IREDELL COUNTY HEALTH DEPARTMENT

IMPROVEMENT PERMIT / AUTHORIZATION TO CONSTRUCT / OPERATION PERMIT / EXISTING SYSTEM INSPECTION

PERMIT # 162938 PIN # 4626 73 9305 DATE August 17, 2010

SUBDIVISION The Farms BLOCK / SECTION 1 LOT # 34 LOT AREA 1.25Ac. DESIGN FLOW 480gpd L.T.A.R. .3gpd/ft²

INITIAL SITE SKETCH

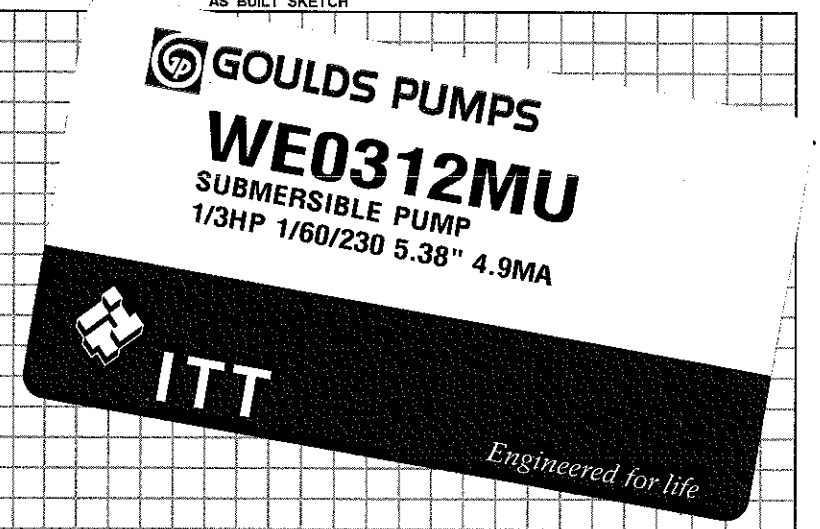
Abandon existing pressure manifold and supply lines

See Plan from Kathleen M. Saunders, LSS Soil / Site Evaluations

Approved by ICHD

AS BUILT SKETCH

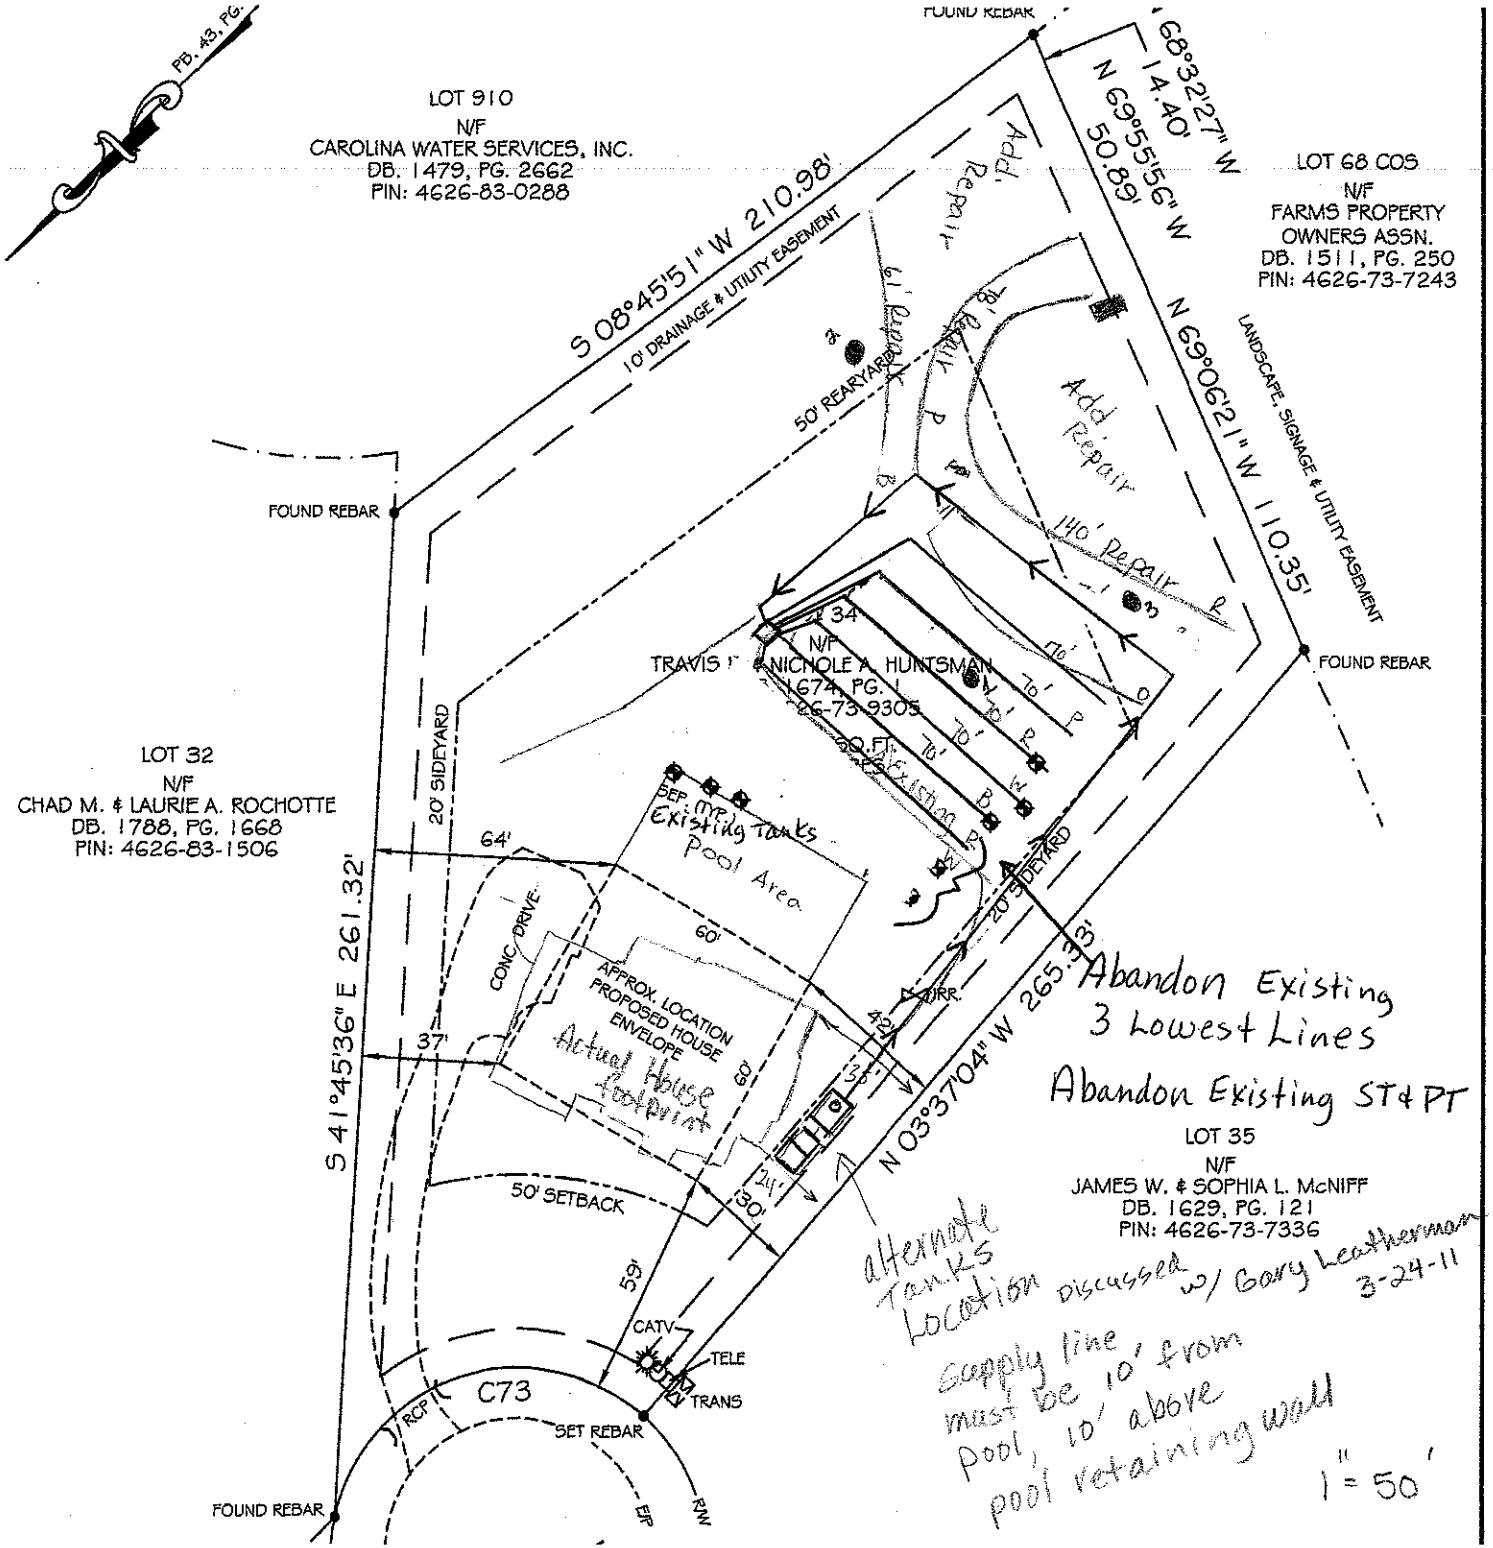
Location of the proposed Pool addition does not appear to impact the existing on-site septic system.**NOTE: [signature] REHS
